Docket Nos. 50-259
50-260
and 50-296

The Commission has issued the enclosed Amendments Nos. 39, 37 and 13 to Facility Licenses Nos. DPR-33, DPR-52 and DPR-68 for the Browns Ferry Nuclear Plant, Units Nos. 1, 2 and 3. These amendments consist of changes to the Technical Specifications in response to your request of May 17, 1978 (BFNP TS 109) regarding impiant electrical system modifications as described in your letter of May 2, 1978. With your concurrence, we have modified the Technical Specifications to more specifically describe the equipment affected by the modifications.

BROWNS FERRY NUCLEAR PLANT, UNITS NOS. 1, 2 AND 3

By letter dated May 17, 1978, the Tennessee Valley Authority (the licensee or TVA) requested changes to the Technical Specifications (Appendix A) appended to Facility Operating Licenses Nos. DPR-33, DPR-52 and DPR-68 for the Browns Ferry Nuclear Plant, Units Nos. 1, 2 and 3. The proposed amendments and revised Technical Specifications would incorporate modifications to the inplant electrical systems to maintain adequate inplant electrical system voltages for three unit operation under all required postulated transient and accident conditions.

Figure 1
Modified Configuration

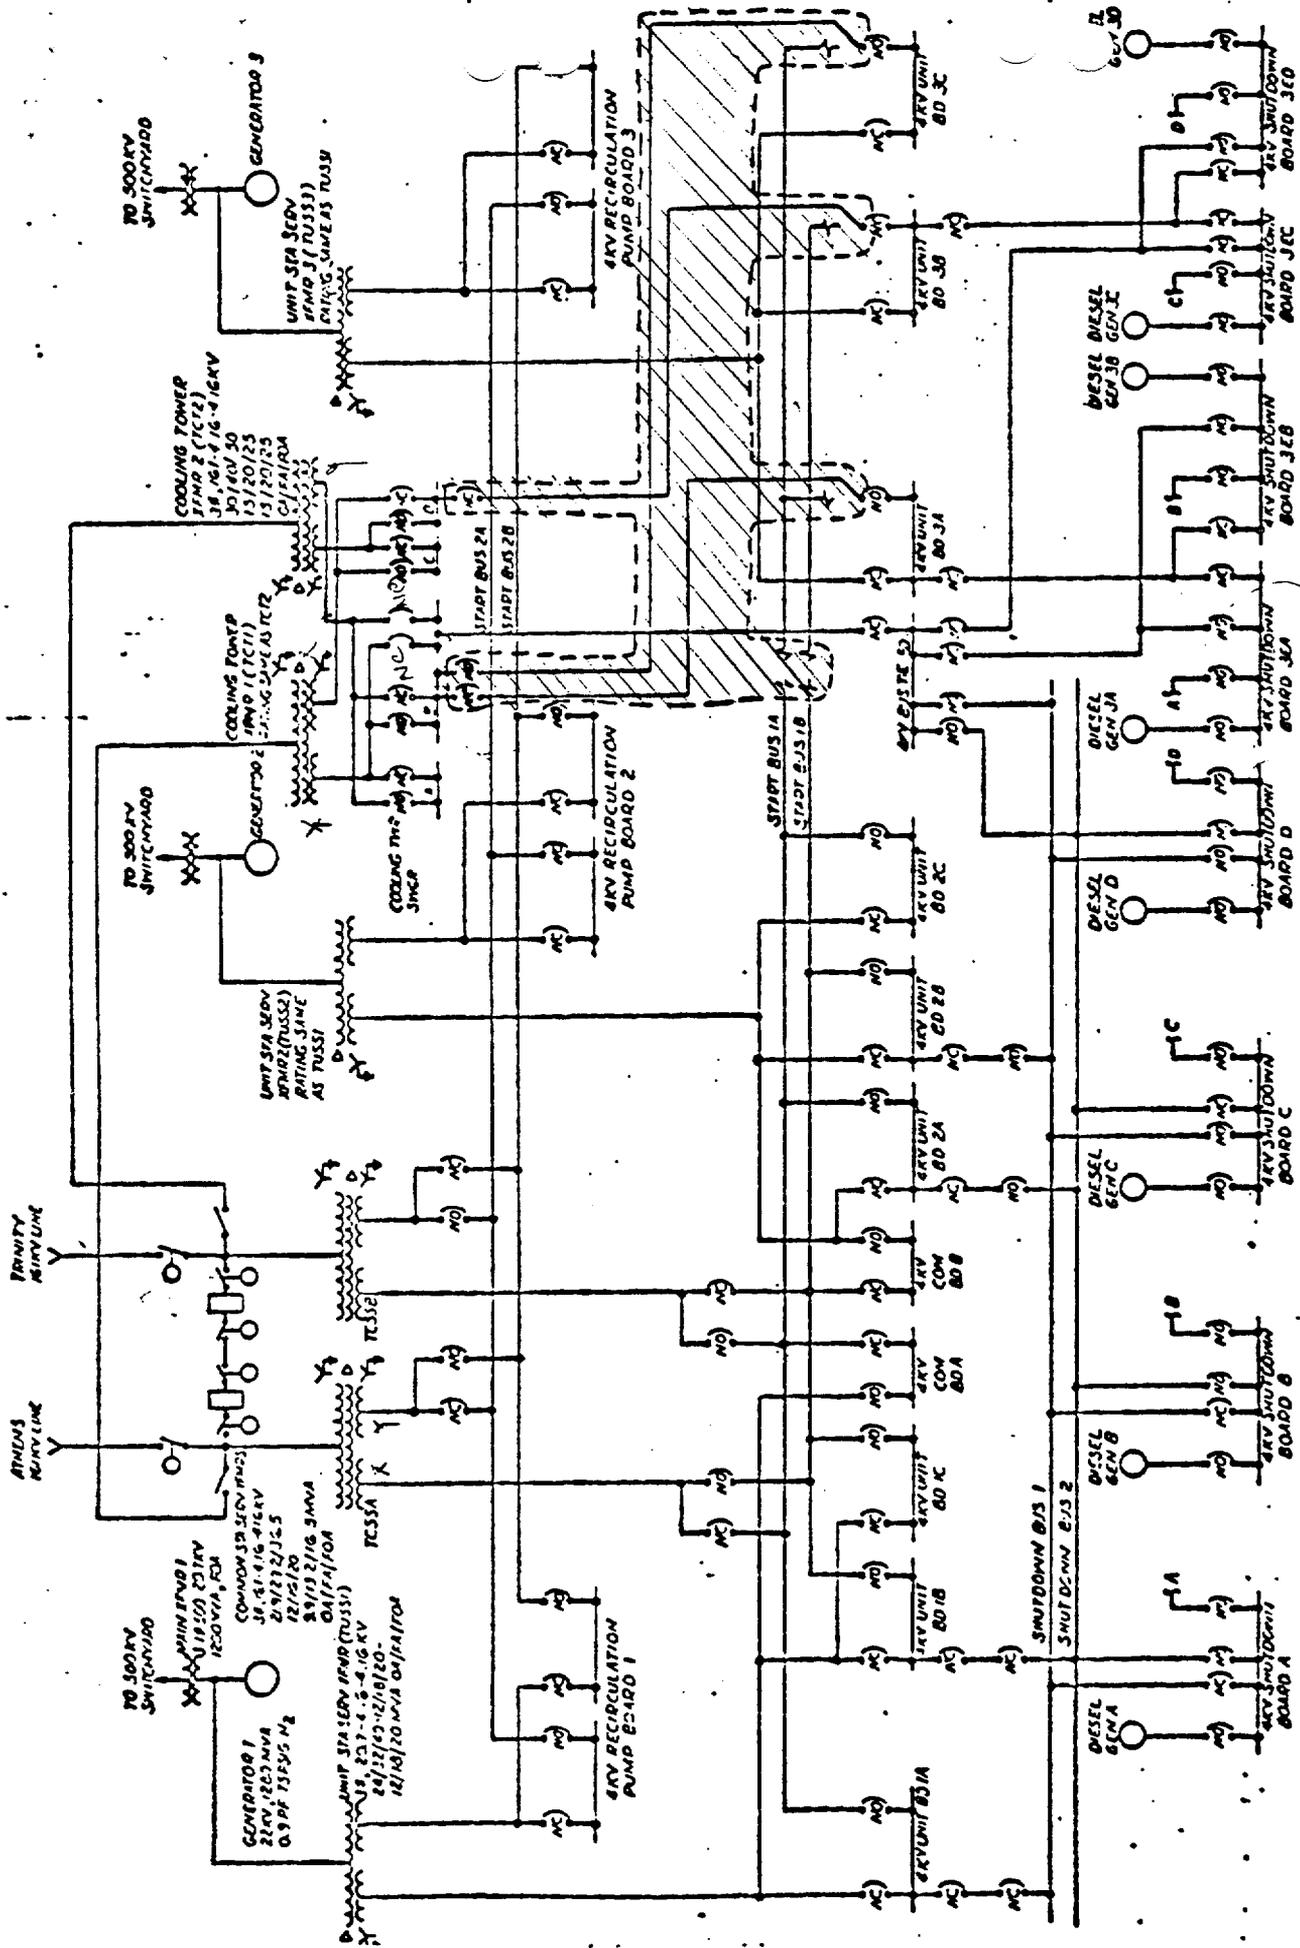
Unit 3 boards 3A, 3B, and 3C will be cut off the start bus 1A and 1B and will be supplied from cooling tower transformers 1 and 2 as shown in the cross-hatched portion of Figure 1. The offsite supplies for shutdown boards 3EA and 3EB, and for shutdown boards 3EC and 3ED are fed through board 3A and 3B, respectively. The 4kV bus tie board can be supplied power by either of the cooling tower transformers and remains unchanged from the original design.

The feeder cables for these offsite power supplies are routed in separate cable trenches to the cooling tower transformers. The system modifications also improve the power factor on the offsite power source by installing the capacitor banks on 161 kV line, and reduce the voltage drop on the inplant system by rearranging the 4160 volt loads to common station service transformers and cooling tower transformers. The modified configuration would result in a voltage of 3950 volts on 4160-volt inplant system for the postulated events.

The staff has reviewed the licensee's proposed modifications to the plant system - the installation of two capacitor banks and the rearrangement of the Unit No. 3 4160 volt loads to improve the inplant system voltage. The staff also reviewed the associated changes to the Technical Specifications resulting from these modifications. Based on the evaluation of the information provided by the licensee, the staff concludes that the proposed system modifications are an acceptable method of assuring that the inplant system voltages satisfy the requirements of General Design Criterion 17 with regard to system capacity and operability. With the changes we have proposed and which the licensee has accepted, the staff finds the changes to the Technical Specifications to be acceptable.
